Woodhouse Place PUD Amendment

RECOMMENDATION REPORT

CASE NUMBER: PPUD-18-0003

RE: Planned Unit Development (PUD) Amendment
Initial Review
Woodhouse Place

PLANNED UNIT DEVELOPMENT SITE PLAN

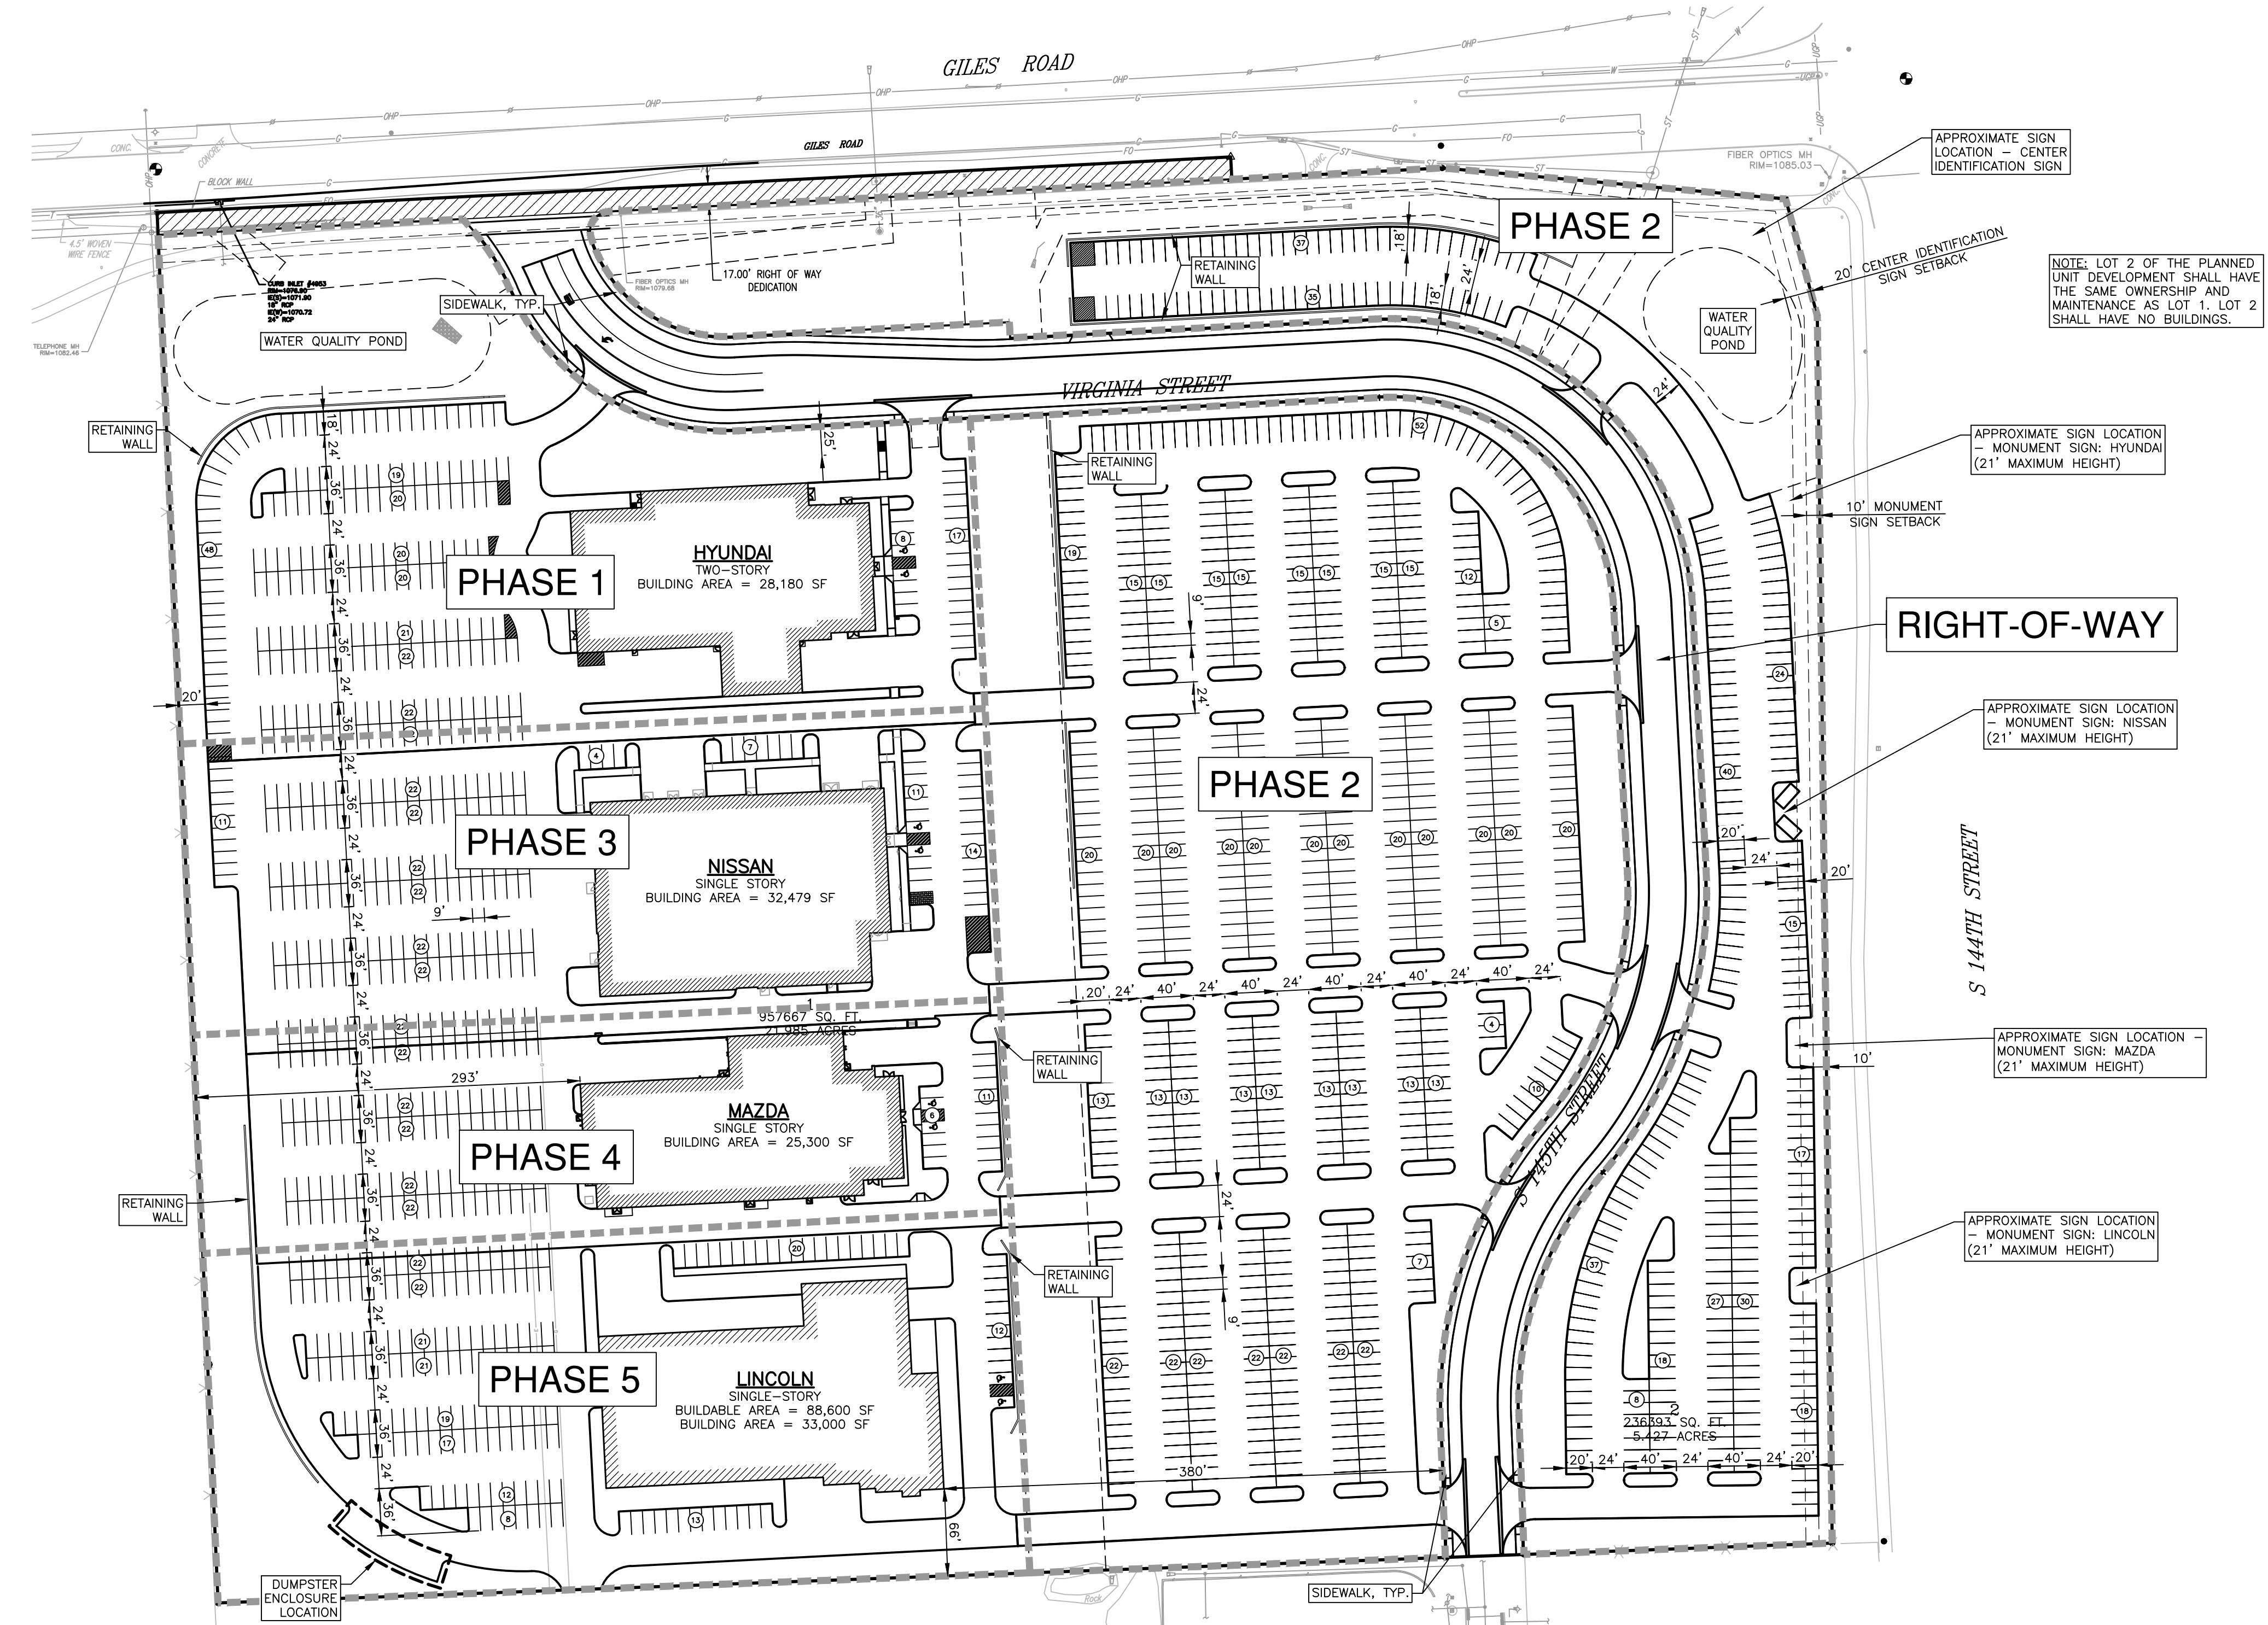
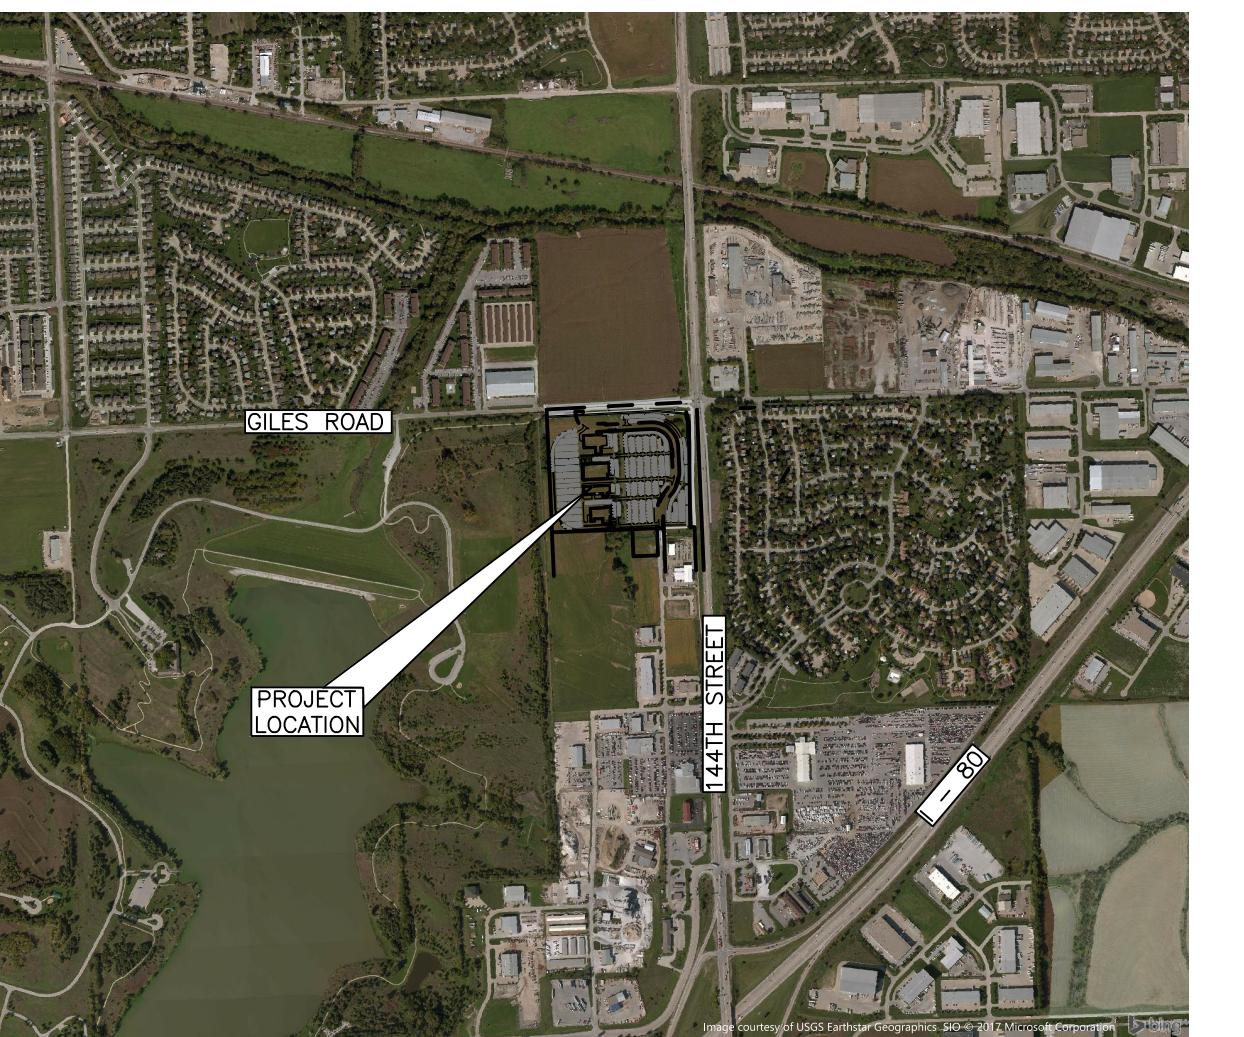
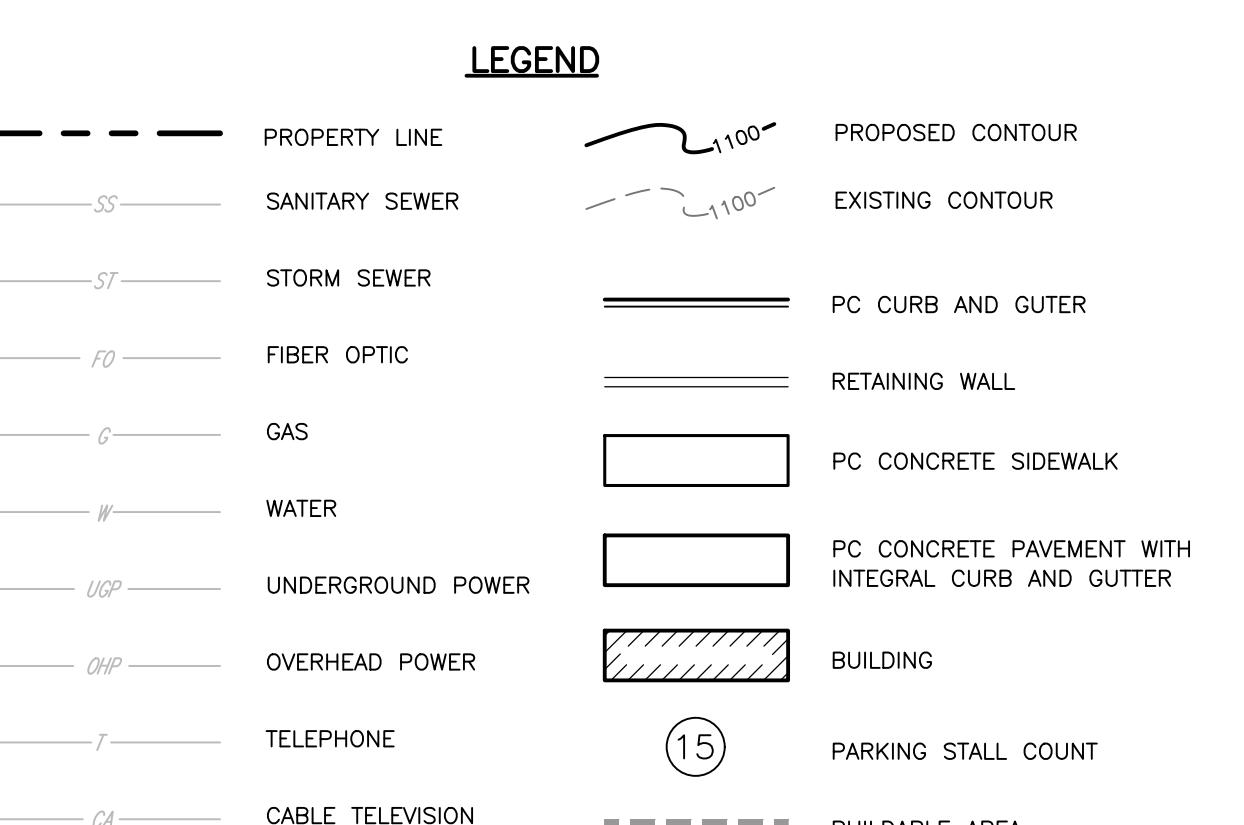
1. The proposed water quality basins should be shown on the PUD site plan. Just the outlines of the basins and the easement areas would be sufficient.

2. Any proposed outside dumpsters should be located on the PUD site plan. Previous communications indicated there would be one at the south end of the project.

3. The amendment should update the building configurations and sizes to the most current information, as there have been some changes since the initial PUD approval.

RESPONSE: The water quality ponds have been indicated as requested.

RESPONSE: The enclosed dumpster locations have been indicated as requested.

RESPONSE: The building footprints shown on the updated site plan are current. If modifications to the Lincoln dealership are made, a future PUD minor amendment will be submitted prior to building permit.
